TEMPORARY CHANGE T-4 to TECHNICAL MANUAL for Radio Receiver R-390A/URR NAVSHIPS 0967-063-2010 (formerly NAVSHIPS 93053).

This temporary change revised the manual to reflect the equipment changes made by Field Changes 4-R-390A/URR and 5-R-390A/URR which appeared in EIBs 655, 661 and 664.

Figure 1. Correction to figure 89-1.

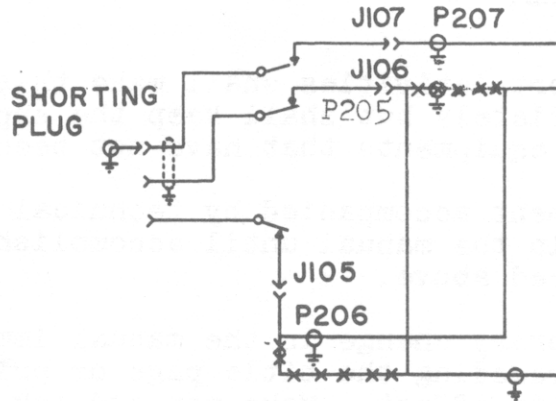
f. Page 178, figure 89-1:

(1) Correct antenna input connections at upper left side of page as shown in figure 1 of this article.

(2) Delete "125 ohm Balanced" in J104 block at left of antenna input.

(3) Below antenna input wiring, write "Antenna input modified on shipboard installations by Field Change 5. Shipboard installations use J103."
